City of Edina: 54th Street Reconstruction and Arden Park Area Stormwater Plan

Design Scenario Stakeholder Feedback

30 September-10 October 2013

East, Scenario 1: Highlights and Unique Features

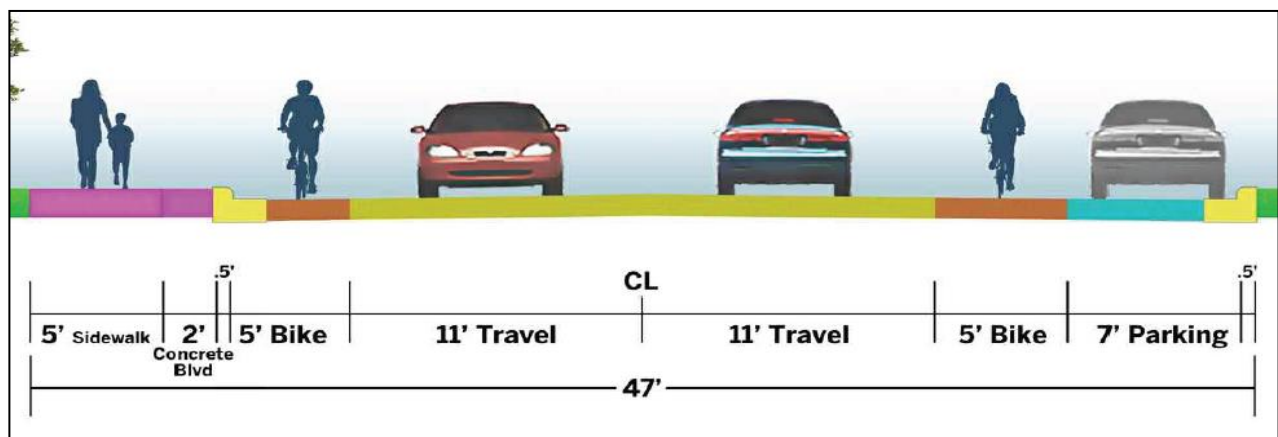
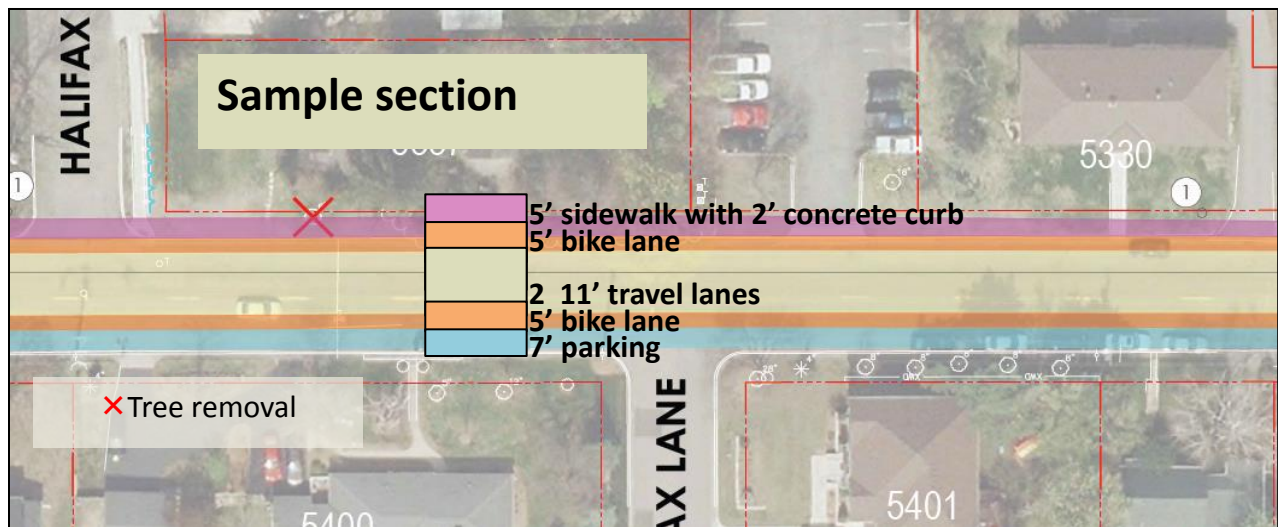
- Need width for winter. Too narrow at Minnehaha boulevard
- Limit the number of bus stops, less rather than more
- Too wide. Put sidewalk in south side, no dedicated bike lanes

- No dedicated bike lines
- No bike lines or lanes
- No dedicated bike lanes
- Too wide! No dedicated bike lanes please
- Don't like 3 (too wide). Scenario 1 or 2 are preferred

- Consider permeable application for 2' boulevard
- Minimize tree removal
- Width of street; don't need dedicated bike lanes; 2' concrete curb is ugly and takes away from appealing greenery

- Do not need dedicated bike lanes for rarely used bike traffic.
- No to bike lanes, no bike lane lines -- impedes driving & unnecessary in winter
- 11Foot Travel Lanes are not wide enough. Will have same problem as we had on Wooddale.

- During church events parking will extend further into Halifax
- tree removed
- street is to wide, loss of tree
- WAY TOO WIDE!! Separate bike lanes are NOT needed. We have spoken to MnDOT....11' travel lanes are NOT required. Nor are the 5' sidewalks or 5' bike lanes. They are merely RECOMMENDED! Should have bump outs for parking and to slow traffic.

- 2 feet for a concrete boulevard? Why is this necessary?
- Why take parking away (north side) and replace with dedicated bike lanes? (they are NOT required on a secondary route); with the exception of Sunday (church) and isolated evenings those parking lanes will be empty and can be utilized by bicyclists

- We can't accommodate the same width on the west side of 54th Street
- Adding the permanent parking lane adds to an excessive road width
- I think the sidewalk has been put on the wrong side of the street. It should be on the south side. People use the south side of the street to go the Lutheran church and the convenience store at 54th and France. I rarely see people walking to Arden Park along this part of 54th Street.

- Shared bike lanes, parking both sides of street.
- Yes to center lines for cars
- street too wide
- concrete boulevard is too wide, I like the west end of 44th is better
- This section is already too wide...SHOULD NOT be wider. Encourages speeding!
- Again, north side of road is bearing the brunt of proposed change
- From what I've heard from residents, the current pastor is using this project merely as a jumping off point for his career ambitions, leaving us with the destructive outcomes!!!
- Tree loss

- Can we better control speeders?
- Why do we need a street this wide?
- Do area residents get a final say? Is there a town hall meeting for resident input, to be heard by city council & engineers?

- why not have two 13.5' shared bicycle/travel lanes
- I am intentionally not weighing in on this section because the opinions of those directly impacted by the scenarios are the only people who should be listened to.

- Loss of tree (against Living Streets Policy)
- Has the church been contacted to get on board with the design?
- Can you consider using the bike lane(s) for Sunday parking?

- Why can't you have a shared-lane (bike/motorist) concept along entire 54th Street? Keep it simple and consistent the entire length; reduces confusion among bicyclists/motorists

- When are the parking lanes most utilized?

East, Scenario 2: Highlights and Unique Features

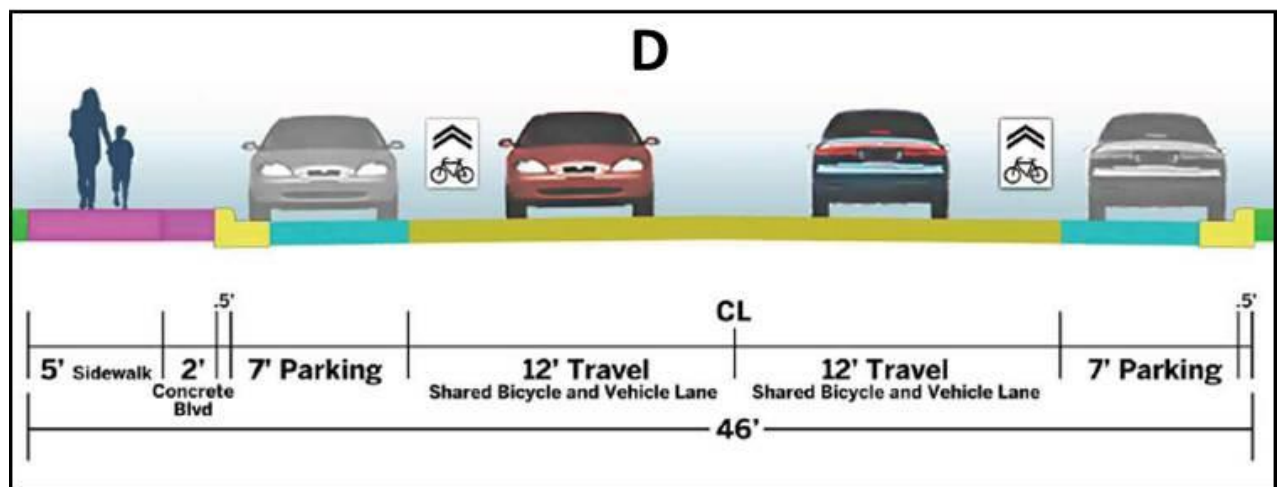
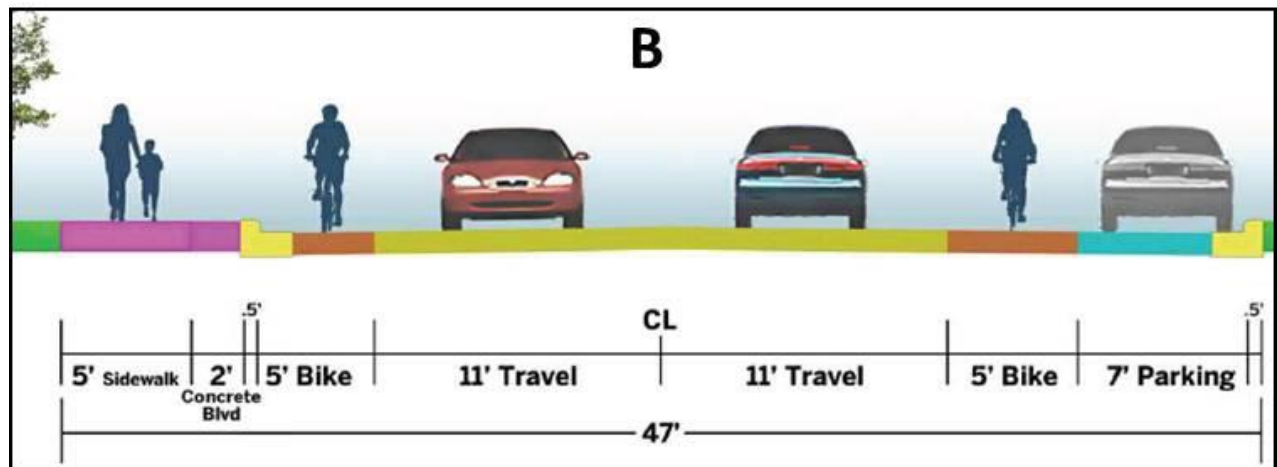
- Is boulevard needed? No 2' boulevard
- Don't like dedicated bike lanes. Prefer parking here
- Consider sidewalk on west side of Minnehaha
- Love "share the road"; dedicated bike lanes are not needed given bike traffic
- As narrow as possible, 11' lanes, please line all others
- Ideal is narrow street shared with bikes, two-sided parking, no sidewalk boulevard
- Less signs, no flashing lights

- Sidewalk needs to be on the church side. South side sidewalk is there
- Sidewalk does not need to be on the south side
- Sidewalk on north side, why?
- No need for dedicated bike lanes, parking instead

- Too wide, no dedicated bike lanes please
- Bike lanes are not required for a state-aid road. Eliminate bike lanes. They are rarely used: yes! I second

- We can be bike "friendly" w/out lanes, signs. We were for 30 years: yes! Yes! Second that
- Move bus stop to in front of church
- The shared bike lane and signs might be confusing to cyclists and drivers

- No concerns
- Why do we have two different scenarios on one street? It makes it feel disconnected and is also confusing to people.
- Parking stops on North side of 54th East of Halifax. Keep shared lanes with parking to avoid confusion.

- no to bike lanes -- no bike lane lines. the bike lines impede car traffic and are not used the majority of time. Waste of tax dollars
- sidewalk and boulevard are too wide

- too wide
- Still too wide. Scenario D is the better of the two, but parking on both sides seems unnecessary when we are striving for narrower, SLOWER roads.

- Either bike traffic benefits from dedicated lanes, or it doesn't. If it does, then the lanes should be continuous and not displaced by parking to serve the church. If bike lanes are not indicated then why include them? You're sending mixed messages not only to cyclists who will have to change their path to avoid parked cars, but also to all of us who want to understand the criteria for adding bike lanes.

- Once again, we have read the documents and spoken to MnDot....we KNOW what the actual requirements are. Please be more honest.
- Transition from dedicated to shared bike lanes confusing for both cyclists and drivers.

- Why introduce a 5' dedicated bike lane for one block? I would just continue with the shared concept all the way to France; KEEP IT SIMPLE

- Parking counts. Is parking needed on both sides?
- Narrower streets are safer...why are we focused on such wide streets?
- why not use two 13.5 shared bicycle / vehicle lanes

- Why do we compromise safe and convenient travel for all modes in order to provide on street parking?
- I would just flip the sidewalk to the south side and connect with the existing church sidewalk

- Have the designers explored creative traffic-calming measures along this part of the road? Curb bump-outs? to help define parking and produce pinch points to help slow traffic? This part of 54th is wider than the west side and drivers tend to drive a little faster at this point. The parking is used heavily on Sunday (obviously) and rarely when church doesn't have activities. The parking lane essentially becomes a bike lane when there's no cars present. Why not kill two birds with one stone? I think more can be done to help make this end of 54th tie in more closely with the west side and make more cohesive. PLEASE explore this possibility!

East, Scenario 3: Highlights and **Unique** Features

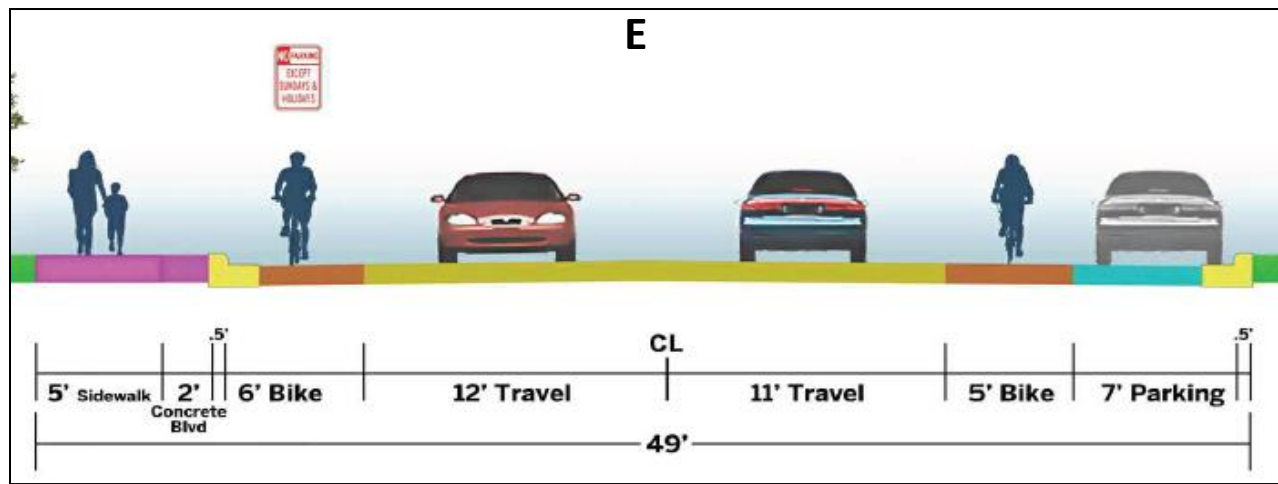
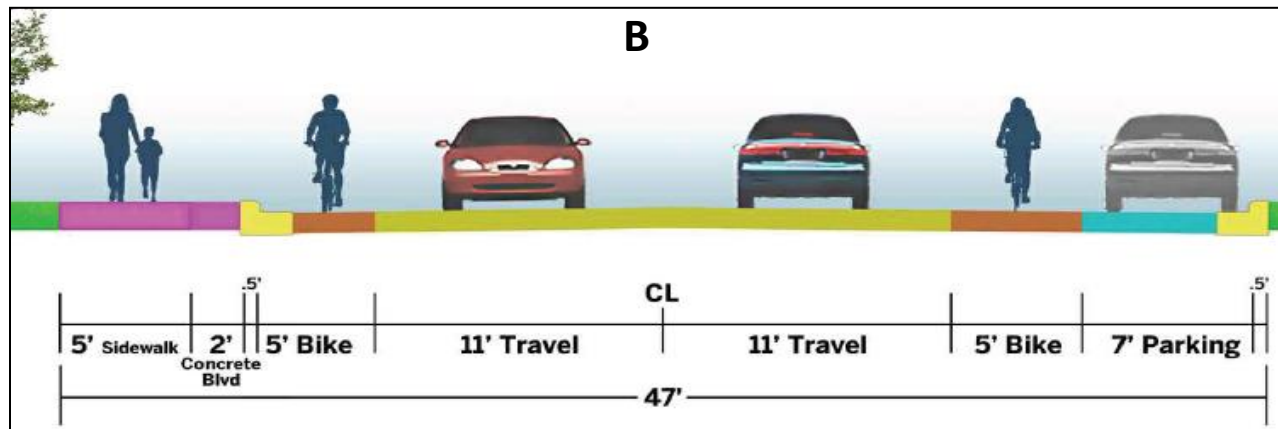
- Scenario 3 is too wide
- Move bus stop to in front of the church
- Too wide! Go to sharrows all the way through
- No dedicated bike lanes. 11' lanes please

- No dedicated bike lanes. Parking both sides
- Sidewalk should be on the church-side of the street
- Sharrows is necessary. No dedicated bike lanes
- Too much emphasis on bike lanes; very little used and they do not follow rules of the road

- Narrow as possible! Do not widen more than existing
- Reduce signage - too many
- We do not need bike lines in the road
- Keep bucolic feel please!
- Opposed to Sunday-only parking, or parking in bike lanes ever

- Too much parking; 2' concrete curb; 2 dedicated bike lanes
- Keep it safe keep it narrow. Do not widen street.
- street is to wide
- street is too wide
- Again, why would we put on street parking ahead of bike lanes IF we believe bike lanes are indicated by traffic volumes (and they are) and other factors?

- Biking is more popular on weekends just like parking, why favor one over the other?
- Getting rid of parking on north side reduces need for sidewalk; will force people to have to park deeper into neighborhoods (wouldn't think neighbors would be too happy with that)
- two bike lanes (not shared)
- Parking both sides for all 7 days/week.
- Dedicated bicycle lanes are not required on secondary bike routes
- big signs

- How do we reduce speed on 54th?
- Why do we need 2 dedicated bike lanes - why can't they share the travel lane?
- why not provide two 13.5 shared bicycle / vehicle lanes
- What is a holiday? For example can I park there on Yom Kippur? How about MLK Jr. day? Once somebody complains, it will be difficult to enforce.
- 5' bike lane with Sunday parking? Why not have a dedicated parking lane that is occasionally used by bicyclists? This stretch of the road will RARELY have the parking used, allowing for 7' to 8' of wide open space for bicyclists; you don't need to have a dedicated bike lane
- Why do we need such a wide road?
- Why have a 2' concrete boulevard?
- Show existing homes/easements in your renderings. Widening road removes trees, utility poles, etc.

Middle, Scenario 1: Highlights and Unique Features

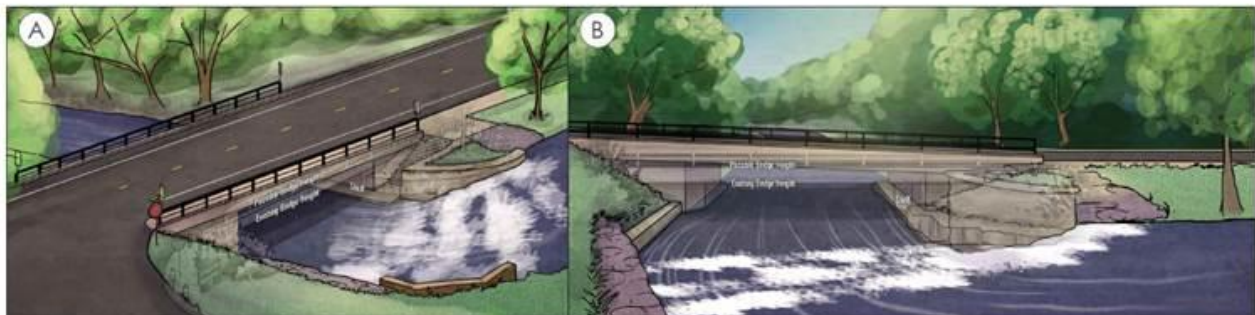
- Bridge needs to be updated
- Allow height for portage (no crossing street for safety)
- Natural canoe landing
- Concerns about under-bridge walkway: access during high water, Height - can you carry a boat over your head?
- Keep natural
- I don't care for the look of a paved boat landing. I like a more natural look
- Erosion control as long as it is not ugly
- Parking "lot" is ugly and unnecessary
- I would not feel safe walking under bridge at dusk/night
- [Under bridge] Great place for kids to drink alcohol
- Concern with illicit behavior under bridge
- Parking is manageable now. No parking lot!
- Goal is to keep bucolic/rural feel. Narrow street. Use bridge material that discourages graffiti
- Clean the creek - preserve the rapids!

- Keep the rapids
- Keep the rapids
- Bridge design is uninspired. Needs character
- Increase the height of the bridge even more
- Get rid of the ugly faux-stone approaches to the bridge; replace with stones and appropriately-sized boulders

- Adding expense to this project by raising the bridge
- People hanging out under shelf.
- do not narrow roadway for cars
- What happened to boat landing area on south side of bridge?

- this rapid is a great resource and I have enjoyed playing on these waves in my kayak many times and would hate to see this really fun spot go away
- May be difficult to provide sufficient width/height under bridge for carrying canoe (especially if on someone's shoulders carrying it solo).

- speed limit, should be 25 mph
- lack of sidewalk on bridge, travel lanes should match the street, hopefully two 13.5' shared bicycle/vehicle lanes
- Room for bike lanes??

- At high water levels (times when boaters may be more likely to want to portage) it is likely the shelf will be under water and unsafe.
- Don't think the bridge should be raised. Worry about people "hanging out" under there. Share the road designation is more than satisfactory.

- Do NOT raise bridge! Being low to the creek is a main reason why people love to go through this area. Feels more intimate, connected to creek. Canoe landing north side of bridge appears to be too close to rapids

- no side walk on bridge
- The current rapids are created by the gradient as well as the concrete apron under the bridge. I am assuming the apron will need to change with a new bridge. Please consult with whitewater park designers to see how best to replace the concrete apron with something safer while maintaining rapids that are desirable to whitewater boaters

- Will raising the bridge cause icing?
- [On 54th facing Minnehaha] Possible canoe landing downstream left?
- Why is the street and bridge not curved to the south to add interest and calming effects and a better view of the rapids

- Why no sidewalk on bridge?
- I am intentionally not commenting on this section because the people most directly impacted should really be the only points of view that count.

M1+2 Boat landing type

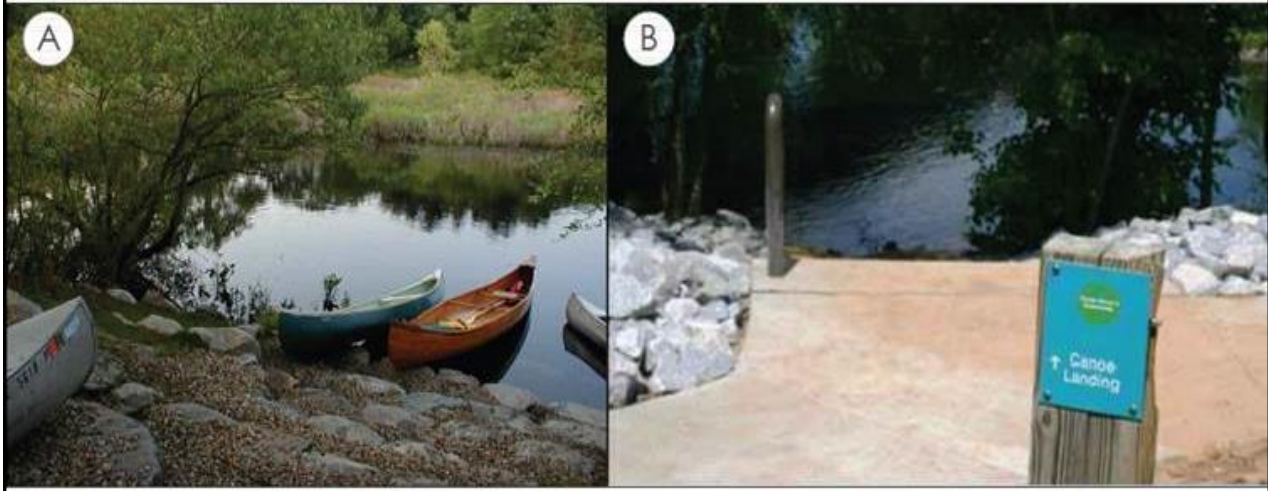
- (A) IS MORE NATURAL, MORE MAINTENANCE;
(B) IS MORE CONCRETE, MORE DURABLE

- A, more natural
- We like A.
- Not necessary
- Option A is the far better option. This area is currently fairly natural and wild. Maintaining a more natural landing is more fitting. However, there is really no need currently to change the landing south of 54th street. This is a deck style landing and completely adequate the way it is.

- A
- A
- B
- more durable
- I prefer the less industrial looking landing A.
- #A The more natural
- like more natural look
- Prefer a
- B
- A
- Keep it natural (A); that's part of the character and ties in more closely with the Living Streets Policy

- A
- ... The "B" look which paves over everything.
- A
- Natural
- A is preferred
- The "A" look has a much more natural and better aesthetic than...
- I like the more natural look

M1+2 Grass pavers to control erosion, and location

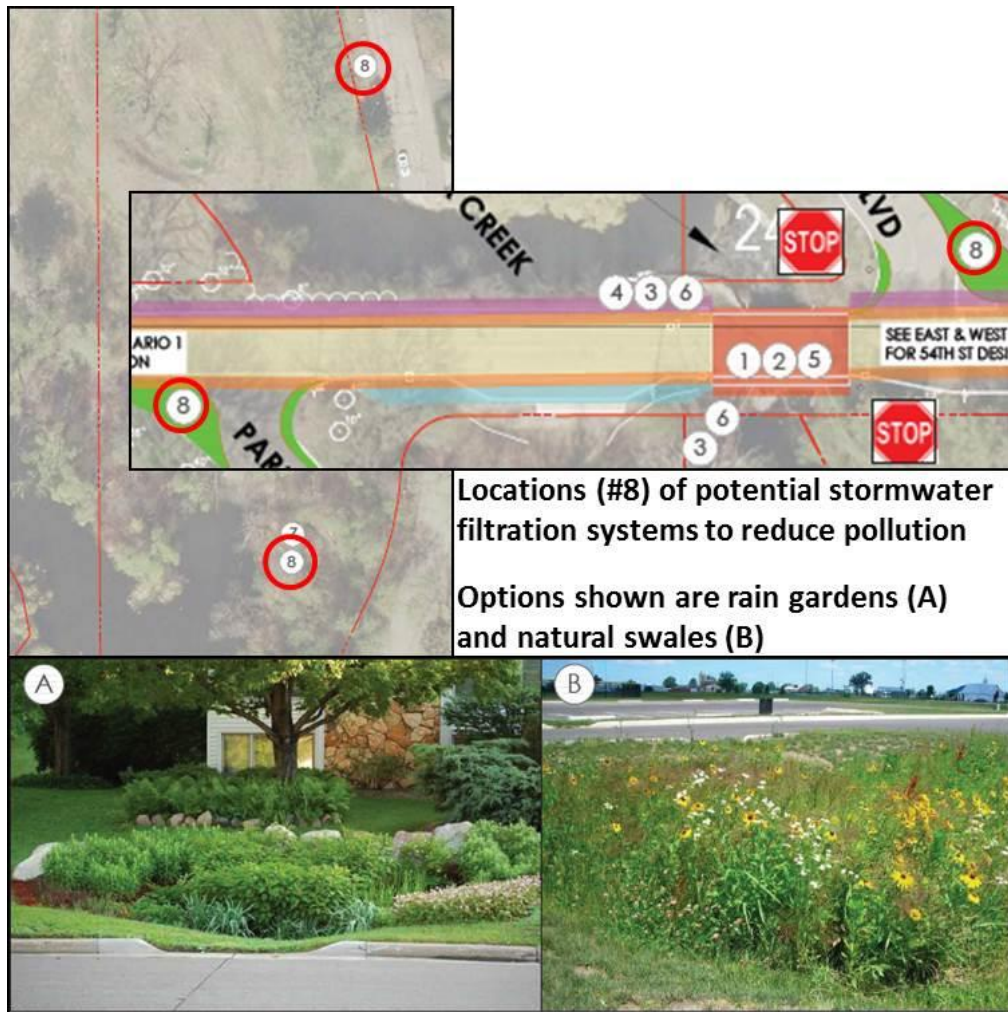
- Good
- good idea
- like the idea, but don't appreciate the use of the creek...too few users to put this much investment into a few months of enjoyment for the minority of people that use it for this purpose.
- Grass paver are a great idea for specific areas.
- Yes
- these look good
- yes
- no, looks ugly and unnatural
-
- this is unclear
- Yes
- Seems to be a good idea
- No opinion either way here...

- Yes.
- Looks ok
- Good idea

- Either.
- rain gardens
- In any location where natural swales can be added to help with stormwater they should be.
- Not sure will really help.
- Use natural Swales. Keep it natural vs. city.

- I like B
- Confused by the drawing; not sure where these locations are but it seems like a fine idea; only concern is upkeep and maintenance; how will this look over time? Option "A" looks great but it looks as if someone is out there tending to it daily; concerned that it will just look like a bunch of weeds.

West, Scenario 1: Highlights and Unique Features

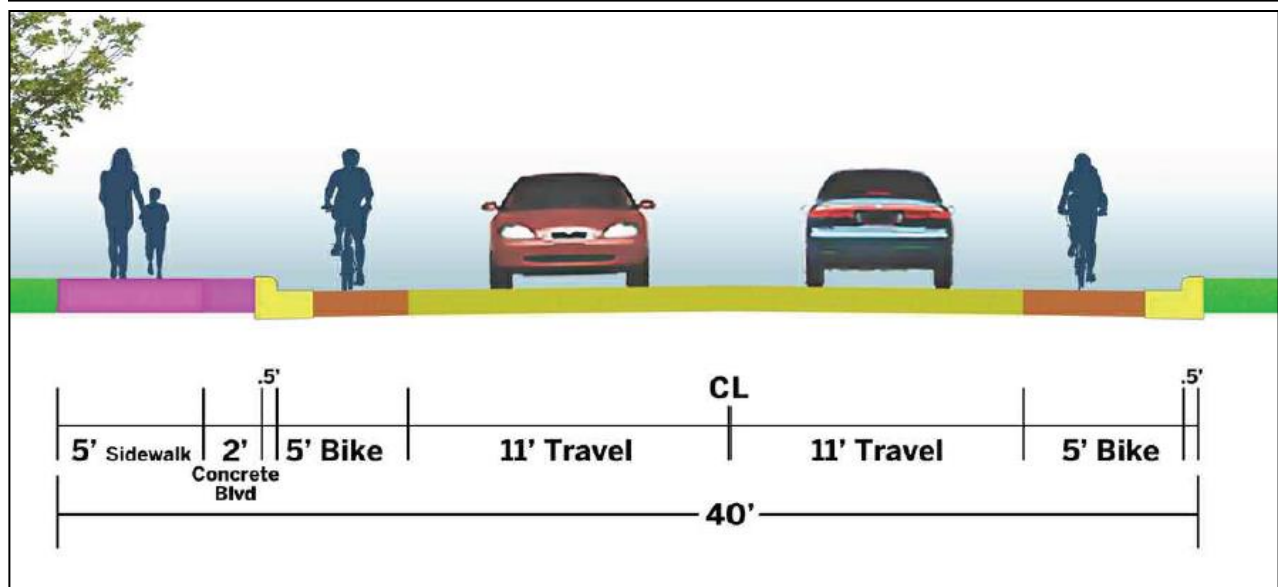
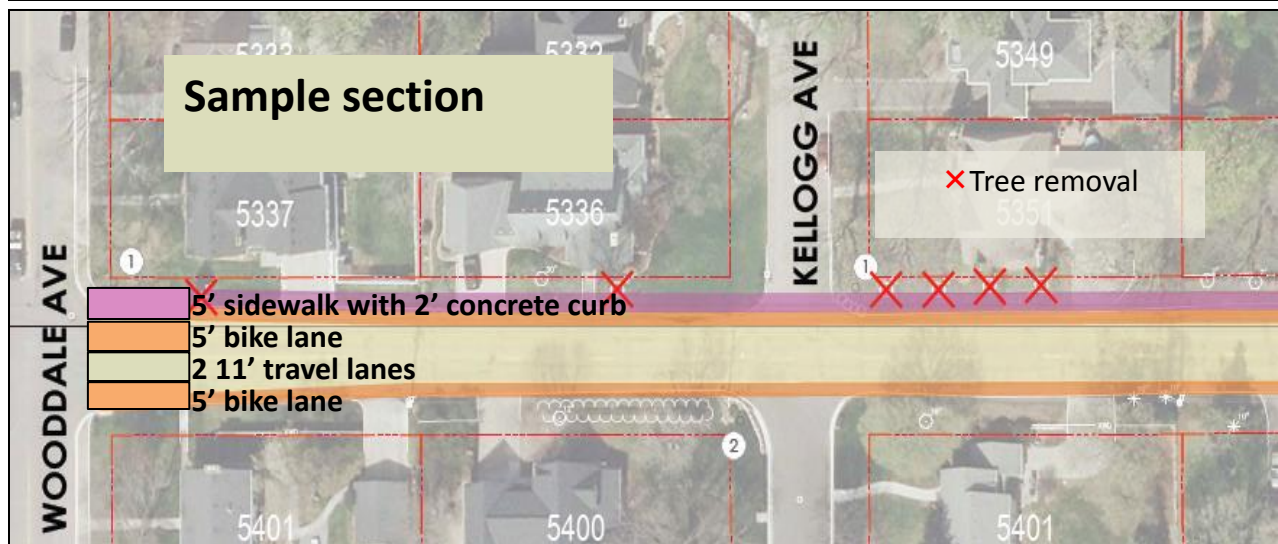
- Do not widen street! Willing to forgo parking
- Dislike due to removal of trees: agree!
- There is no good reason to remove trees: agree!
- 40' roadway is too wide. Too close to houses: agree!

- Inequitable amount of land taken from North side of street for sidewalk
- The street and add-ons are MUCH TOO WIDE
- 2 ft. concrete boulevard. is unnecessary

- what is the budget?
- North side bears the brunt of the expansion; NOT fair to those residents; REALLY? Replace garage? NO! Unnecessary expense and absolutely UNACCEPTABLE! Just don't encroach much further onto property!
